# SERVICE BULLETIN

M-1049

## FLT MODEL FRONT FORK AIR CONTROL BANJO BOLTS

Figure 1. Tighten Front Fork Air Control Banjo Bolts to the Proper Torque

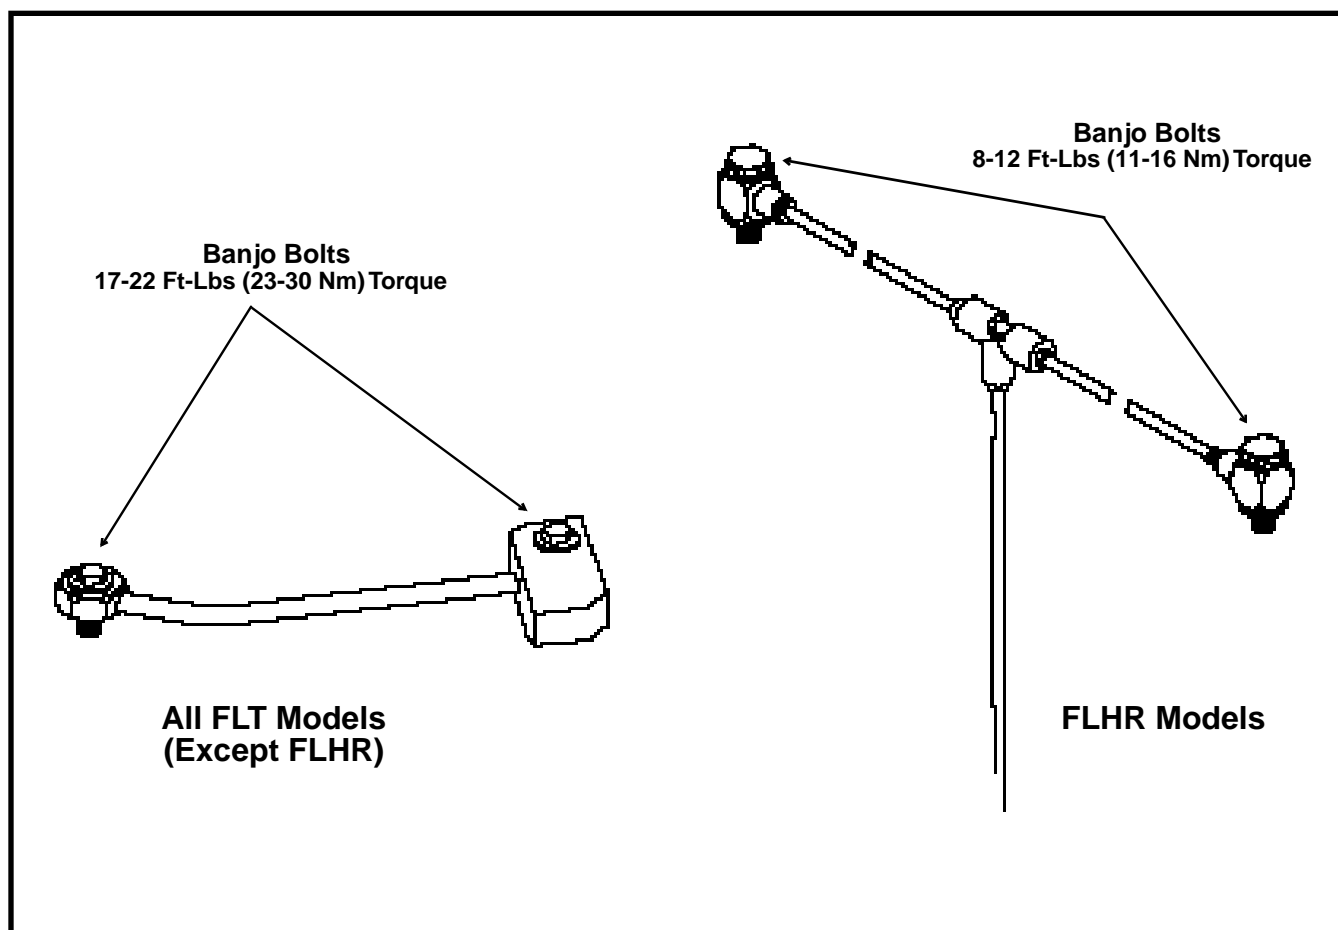
Please be advised that the torque given for the front fork air control banjo bolts in both the 1993-1994 and 1995 FLT Service Manuals, namely 25-30 ft-lbs (34-41 Nm), has been reduced.

The banjo bolts will be damaged if the new torque specification is exceeded. Since individual banjo bolts are not available for FLHR model vehicles, purchase of the entire air manifold assembly would be necessary.

See Figure 1. With the exception of the FLHR, the specified torque for the two drilled banjo bolts used in the front fork air control assembly on all 1993-1995 FLT model vehicles is now 17-22 ft-lbs (23-30 Nm).

The torque for the two banjo bolts used in the front fork air control assembly on all FLHR model vehicles is 8-12 ft-lbs (11-16 Nm).
